**IN REPLY REFER TO:
NCPC FILE No. ZC 15-14**

PROJECT Consolidated Planned Unit Development and Related Map Amendment at Squares 744S and 744SS (DC Water) O Street Pumping Station Bound by N Place, SE, Canal Street, SE, private property, and the Anacostia River	NCPC FILE NUMBER ZC 15-14
	NCPC MAP FILE NUMBER 41.11(06.00)44278
SUBMITTED BY Zoning Commission of the District of Columbia	APPLICANT'S REQUEST Approval of report to the Zoning Commission of the District of Columbia
	ACTION TAKEN Approved as requested
	REVIEW AUTHORITY Advisory 40 U.S.C. § 8724(a) and D.C. Code § 2-1006(a))

Executive Director's Recommendation

PROJECT Consolidated Planned Unit Development and Related Map Amendment at Square 744S and 744SS (DC Water) O Street Pumping Station Bound by N Pl. SE, Canal St. SE, private property, and the Anacostia River	NCPC FILE NUMBER ZC 15-14 NCPC MAP FILE NUMBER 41.11(06.00)44278 APPLICANT'S REQUEST Approval of report to the Zoning Commission of the District of Columbia
SUBMITTED BY Zoning Commission of the District of Columbia	PROPOSED ACTION Approve as requested ACTION ITEM TYPE Consent Calendar
REVIEW AUTHORITY Approval of Comments to the Zoning Commission of the Distric

ROOF PLAN

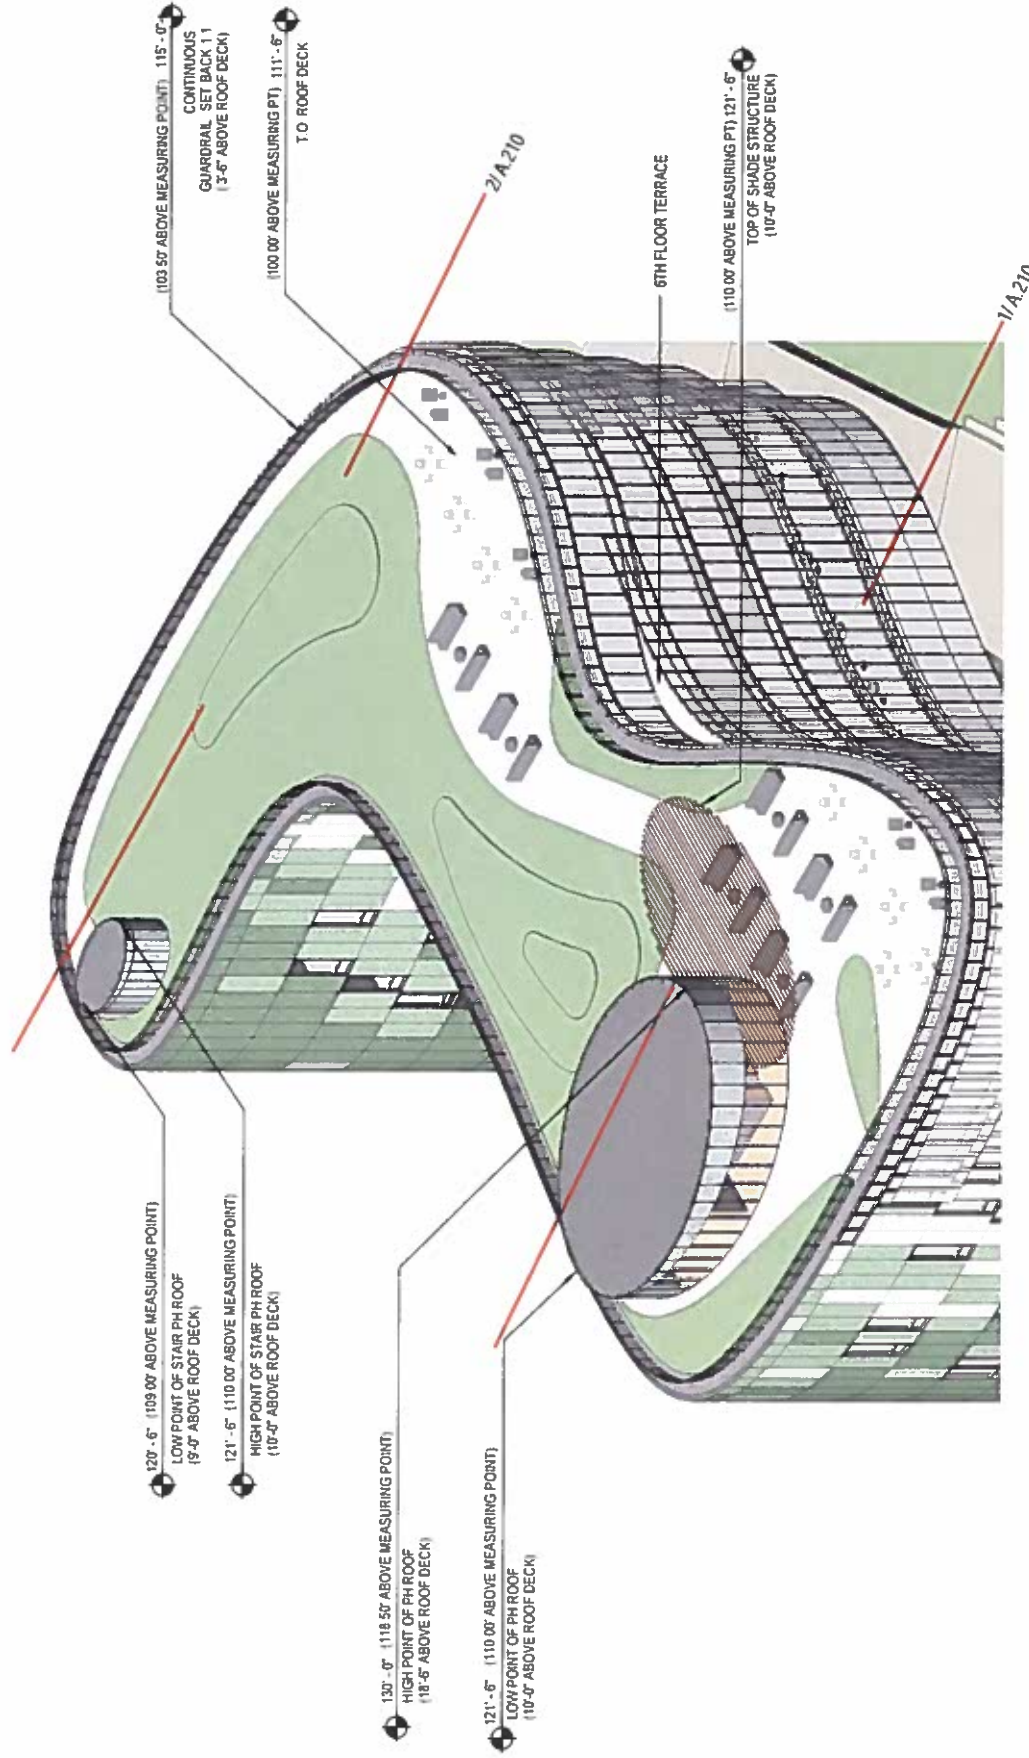
- The Consolidated PUD's proposed height of 100 feet is at the allowable height under the Height of Buildings Act (Height Act) feet based on the 80-foot right-of-way width of Canal Street SE. On December 21, 2015, the applicant provided revised drawings to the Zoning Commission that eliminated a proposed parapet that exceeded the allowable height under the Height Act; the revision now includes a continuous 3'6"-high guardrail that is set back from the roof edge at a 1:1 ratio, which conforms to Height Act requirements.
